Redmond City Center 16135 NE 85th Street, Redmond, WA

Design Review Presentation
December 17, 2015

Fire Comments and Responses:

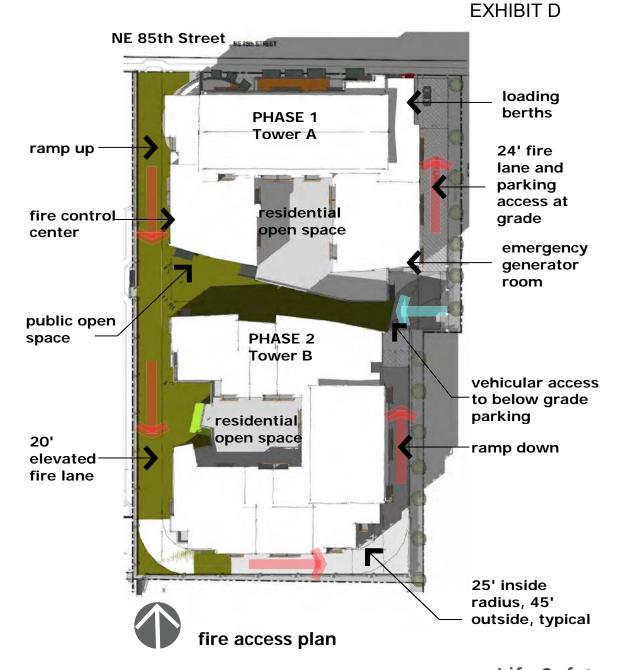
Multi family developments with greater than 100 units are required to have not less than 2 access points to the public road system, per Appendix 2. We are proposing 2 EV access points shown on this page.

Where are the lobbies for the two towers, how do fire police and non resident public interact with this building? How do people get off the podium? Where are the stair tower discharge points at grade? 12/26/13 Show the location of the street level termination of the required roof access stairways for each tower. See pages 13-15

Fire access roadways are required to be with in 150' of all portions of the exterior wall first level. How is this achieved for phase 2 and the south side retail? Suggest a grade level access road on east side from 85th sout to 83rd. Possiblly depressed to access garage level. 12/26/13 the parking garage with the two residential towers are a single building, provide an access road that complies with the requirements of RFD Standard 2.0. this layout provides a fire loop around the entire complex.

Water line and hydrant spacing/locations? 4 hydrants are required with a fire flow not to exceed 3500 gpm. See civil Information

What building code section is this structure being constructed to, are you planning on using IBC Section 510.2? This structure is considered a single building with two towers, one address and unit numbers will be assigned during the Civil review process. We are proposing to classify this complex as one structure with out a horizontal fire separation. See page 11

When a floor level is greater than 75' above the lowest level of fire department access, the building is considered a high rise structure per the building and fire codes. Yes it is a highrise. See page 11.

High rise buildings in Seismic category "D" require a secondary water supply for the fire sprinkler system sized in accordance with 2012 IFC Section 903.3.5.2. See page 13 for proposed location of secondary water vault.
